New Wrapper Design for FCOJ Units

Technical Bulletin Reference No. 2107-001

New Location for Lancer Patent Information

Technical Bulletin Reference No. 2107-002

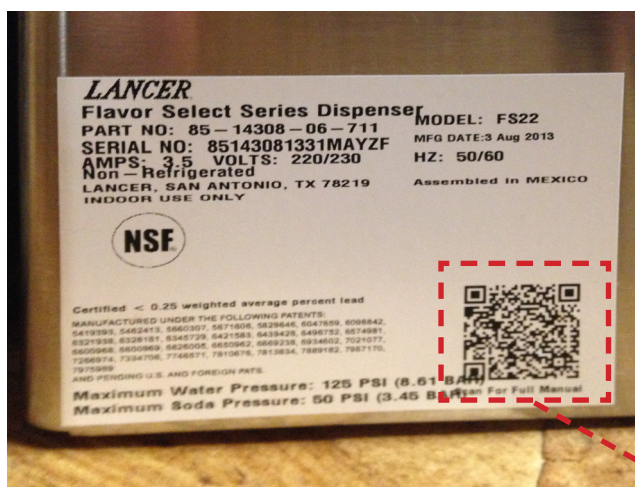
Due to changes in government patent law, Lancer is taking an opportunity to further advance its use of QR Codes by integrating a unit's Patent information. Normally a Lancer unit's Patent information is found on the Name Plate labels located on the front or side of the unit, however, beginning in September 2014, a unit's Patent Information will be relocated to two different locations:

1. Each of the Product Landing Pages located on the Lancer Corp website: lancercorp.com
2. The unit's Technical Document page accessed by the QR code found on the unit's Name Plate Label
